## **Appendix B**

# **Responses to NRC Questions**

<b>Page</b>
Responses to Questions on GESTAR II Revision 5	US.B-3
Responses to Questions on the Barrier Fuel Amendment (Amendment 6)	US.B-113
Responses to GESSAR II Questions Regarding SRP Section 4.2	US.B-120
<b>Responses To Questions On The Fuel Loading Error Analysis (Amendment 28)</b>	<b>US.B-126</b>
Responses to Questions on Additional Amendments (References)	US.B- <del>126</del> <b>136</b>

Figure 5.2-3.  $K_f$  Factor

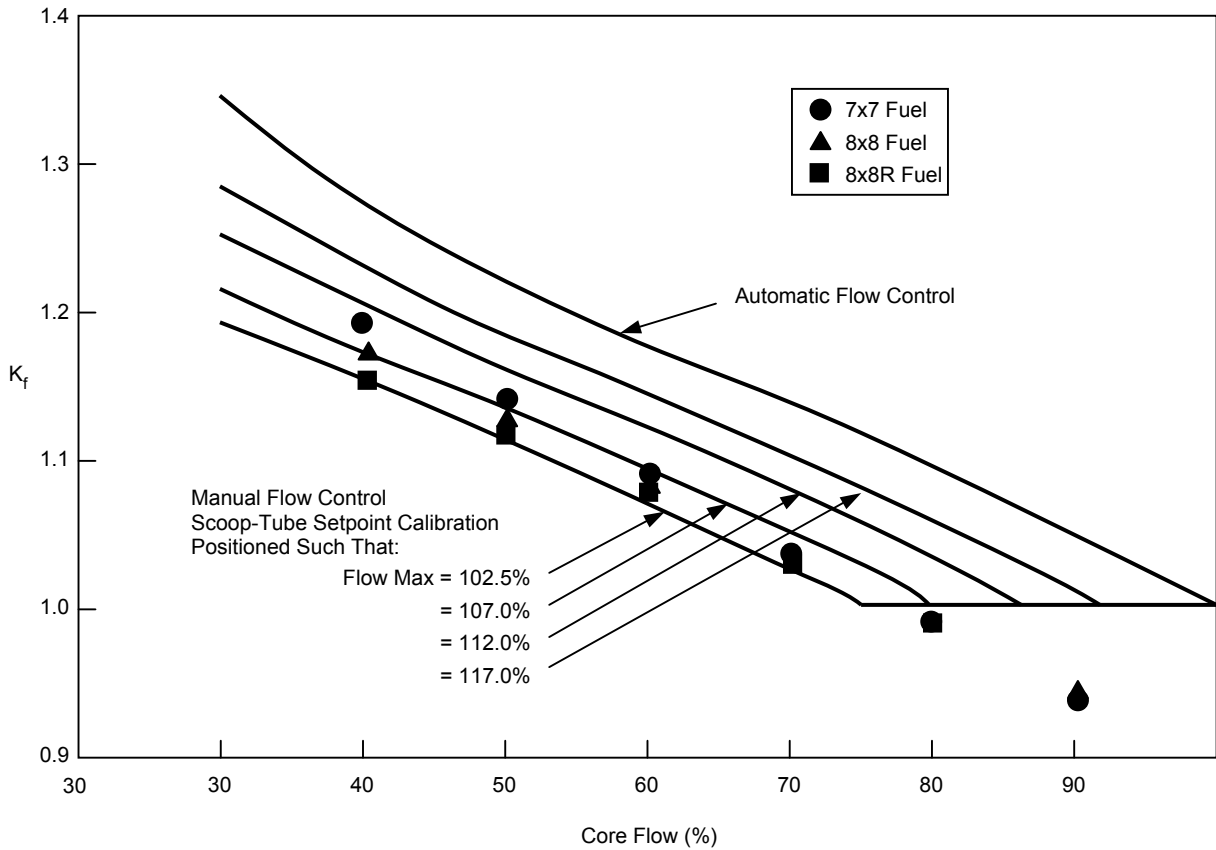
The brief paragraphs, which discuss the operating limit MCPR/low flow correction curves,  $K_f$ , for reduced core flow conditions, do not adequately describe the basis for the construction of the generic curves shown in Figure 5-7. A substantially more detailed discussion of the procedure employed is required. Describe the models, methods and assumptions used, which make the curves generic for BWR/2, BWR/3 and BWR/4 plants incorporating up to three different fuel designs. Either justify why the new fuel design (8x8R) is conservatively bounded by the analysis or provide an additional thermal hydraulic analysis to demonstrate that the indicated curves are bounding. Clearly state the criteria used for developing the curves for the automatic and manual flow control modes.

Figure 5.2-3 compares the derived 102.5% core flow  $K_f$  curve with the standard curves (Figure 5-7). These results show that the 8x8R fuel closely follows the 102.5% line, but the 7x7 fuel is 3.3% nonconservative at 40% core flow. However, the  $K_f$  curves are conservative for all cores with 7x7 operating limits greater than 1.23.
